Technical Service Bulletin							
Date	Issued	Model Year(s)	Affected	Model(s) A	ffected	-	TSB#
02/04	4/2011	2010-20	11	Diesel Pu	ishers	382	
		Brai	nd			Т	уре
All		American Star		Mountain Aire	X	All 🗆	тт□
Cypress		Dutch Star	×	Kountry Aire		FW□	CA□
Northern Sta	ır 🗆			Essex	IXI		
Scottsdale			X	London Aire		DP⊠	DB 🗆
All Star ME		Ventana	X	Bay Star	-		
□ Air C	onditioning a	& Heating	[☐ Electrical Cor	mponents		
□ Appli	iances & Acc	essories	1	☐ Exterior Com	ponents		
☐ Cabir	nets & Furnit	ure]	☐ Interior Comp	onents		
☑ Chass	sis Compone	nts]	☐ Plumbing & I	Bath Compo	nents	
□ Cons	truction Com	nponents	1	□ Windows, Aw	nings, Vents	s, & Door	s
		С	escription of F	Problem			
Certain Spartan Motor recreational vehicle chassis' equipped with Cummins 2010 ISB, ISC, or ISL CM2250 Engine having a VDM (Vehicle Date of Manufacture) of January 28, 2010 through July 29, 2010 may contain inaccurate DEF (Diesel Exhaust Fluid) Gauge readings in the Lightbar Message Center.			29, 2010,

CSB10-560-001

Instrumentation – Light Bar/LMC (Lightbar Message Center)

Subject: ISB CM2250 and ISC/L CM2250 ECM Calibration and SCR Upfit Campaign

Appendix C

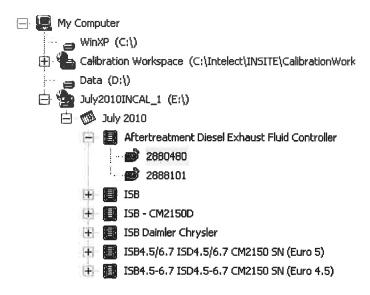
The DEF controller calibration can be downloaded just like a ECM calibration using a July 2010 or later INCAL DVD. To avoid troubles with the DEF controller calibration it is necessary to use a USB connection from the computer to INLINE adaptor. It is also important to utilize the 3 pin SAE J1939 data link connector at the front corner of the engine rather then the 9 pin connector in the cab. Ensure that when the cap is pulled off, the 3 pin connector face is green.

The adaptor needed to connect from the Inline to the 3 pin connector is Cummins part number 3165141.

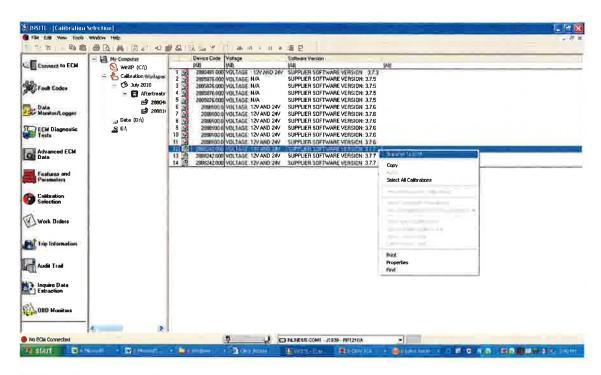
Click on Aftertreatment Diesel Exhaust Fluid Controller to obtain the calibration.

Click on file 2880480. All of the calibrations may be displayed.

Locate the correct aftertreatment DEF calibration- 2888242. Transfer it to the ECM.

Note: Three calibrations may be shown but any one of them can be selected.
